RE: Staff Review Comments for Preliminary Level II and Level III Site Plans

Project Name:	Pamela Road Extension/Subdivision Amendments	Project ID:	2013-097
Address:	Pamela Road	CBLs:	389-D-10, 11, 12, 13, 14
Applicant:	Telos Capital		389-E-2, 3, 4, 5, 6, 7
Planner:	Nell Donaldson

AMENDED SUBDIVISION PLAN
CRESTVIEW ACRES, PORTLAND, MAINE

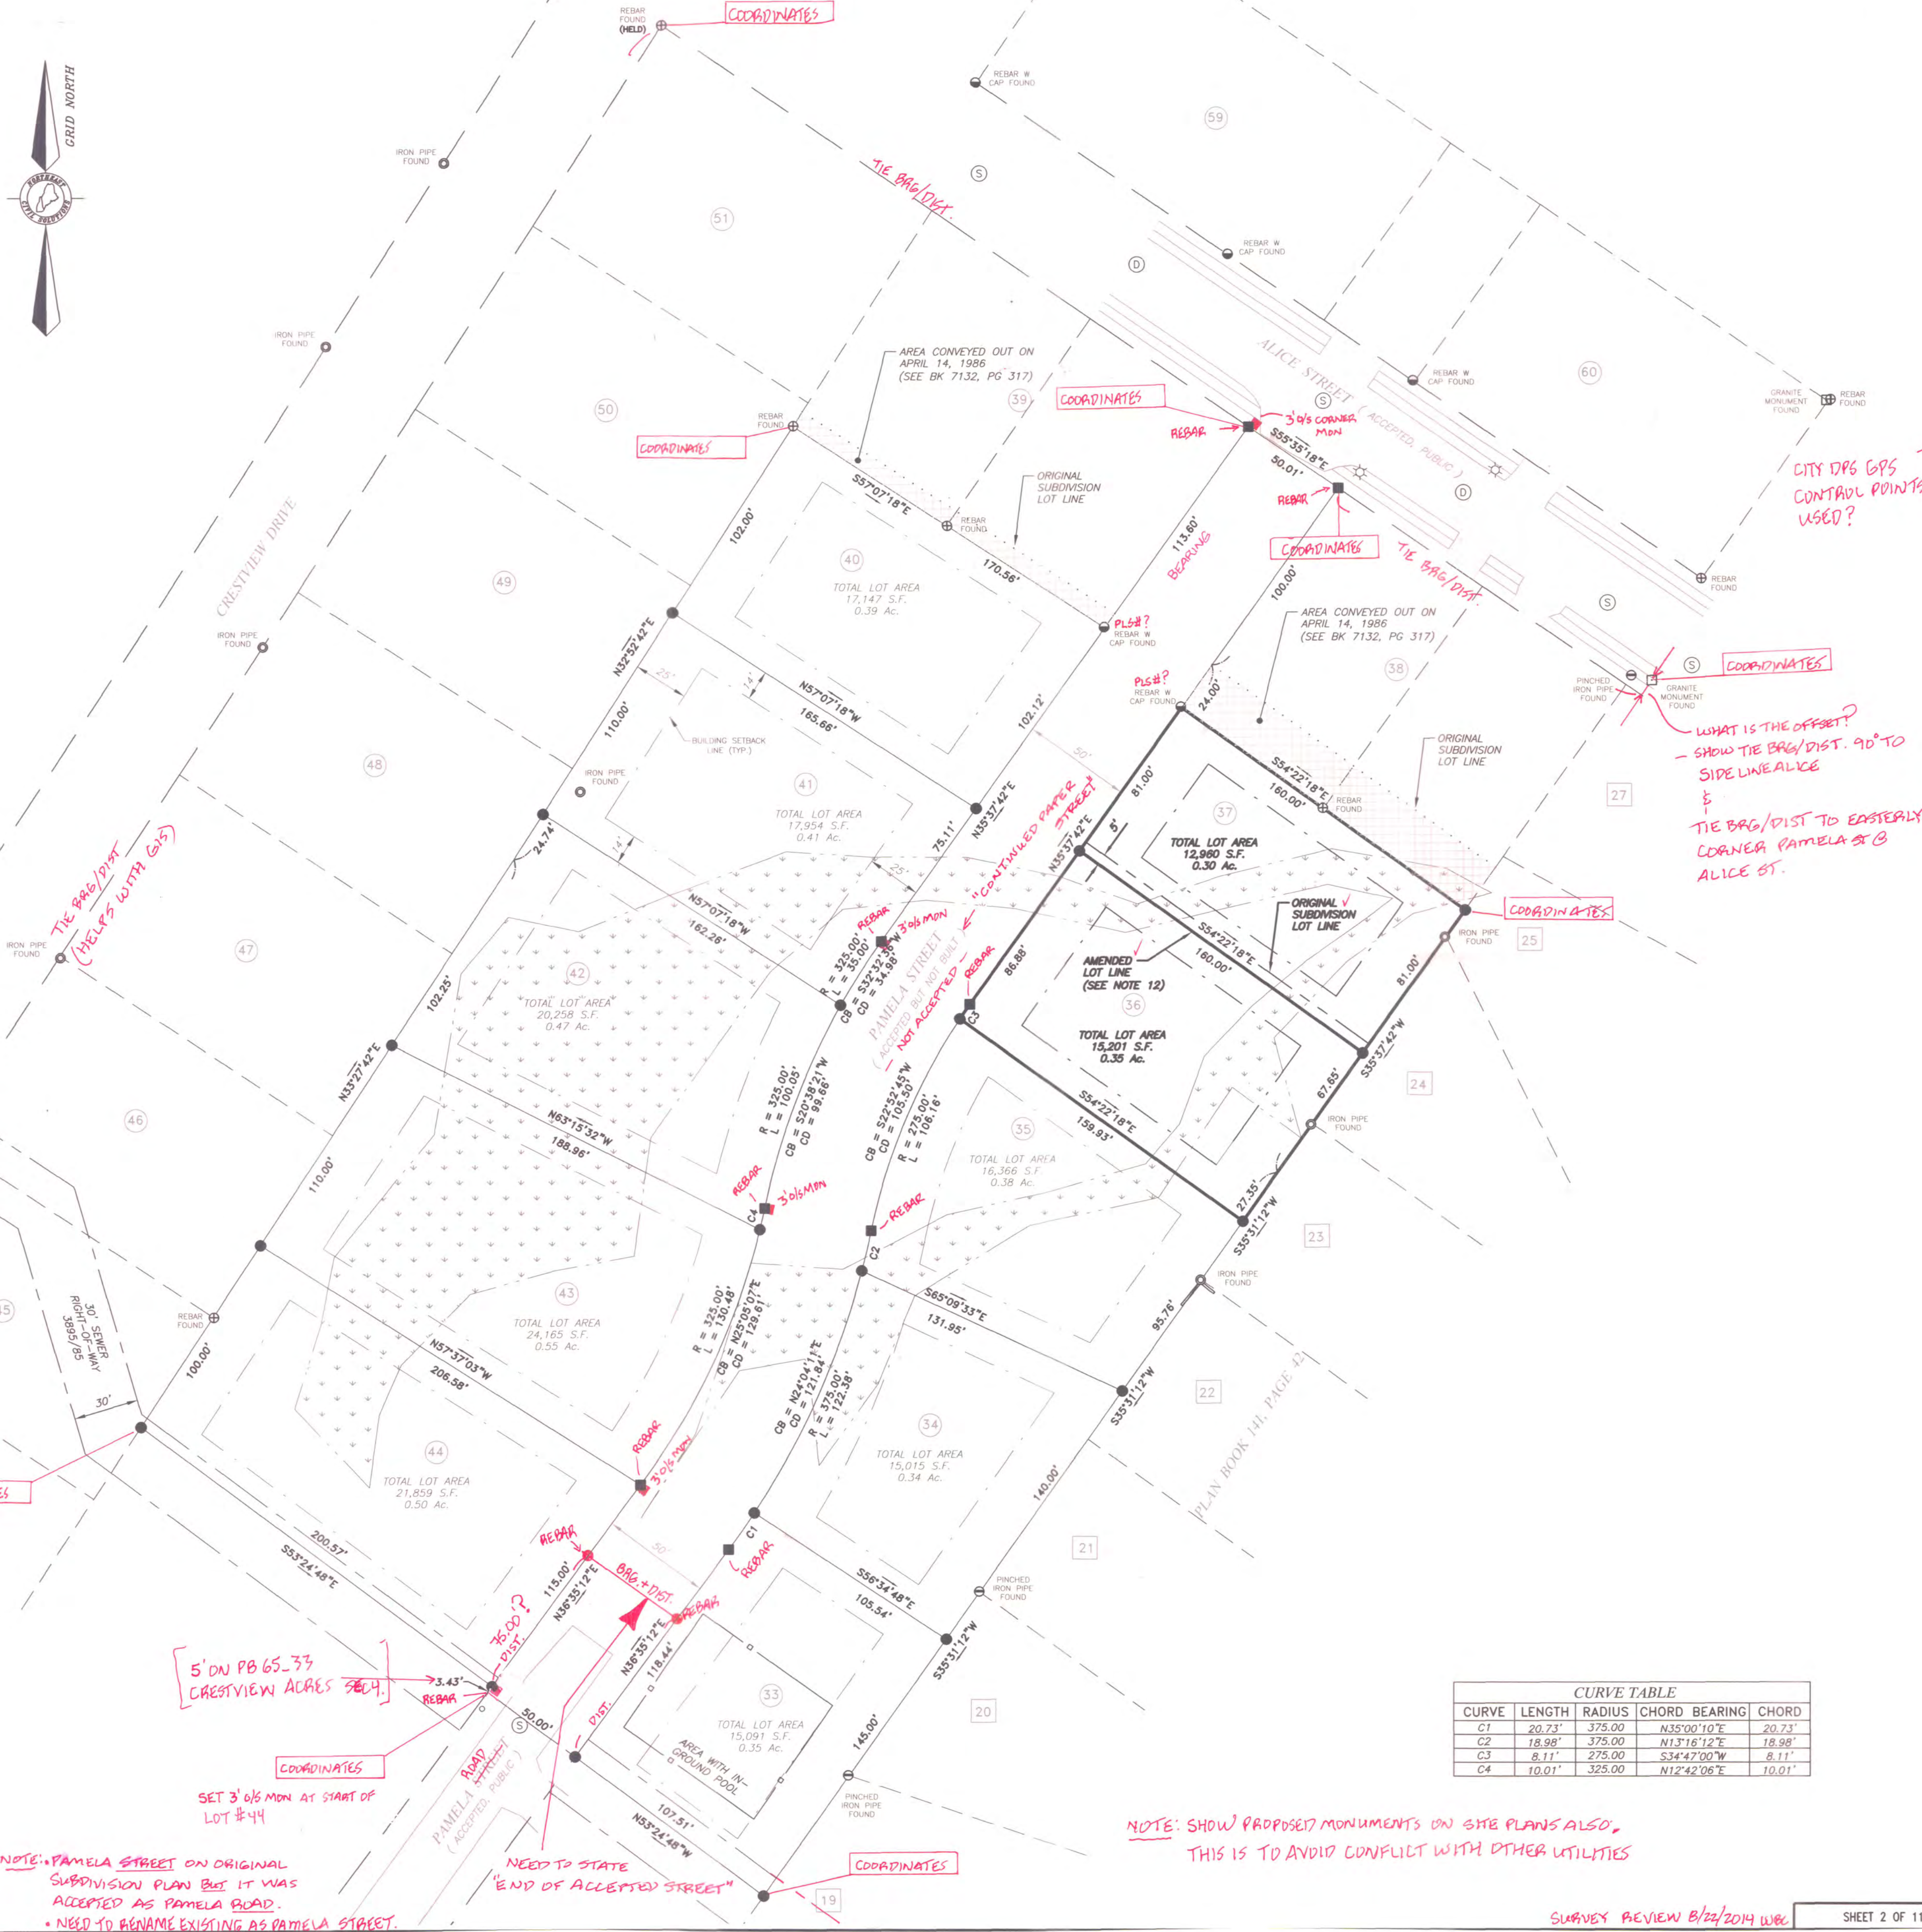
- *[The plat does]not show the end of the existing acceptance. It may go 75.00 feet along Lot 44 to where the new acceptance will start. Their surveyor will need to verify this.*
- *Only need to set granite monuments on one side of the street along the 3.00 foot offset line.*
- *Need to show monuments on site plans also so there will not be any conflicts with other utilities such as buried electric ETC.*

Bill Clark has provided a markup, which is provided as Attachment 1.
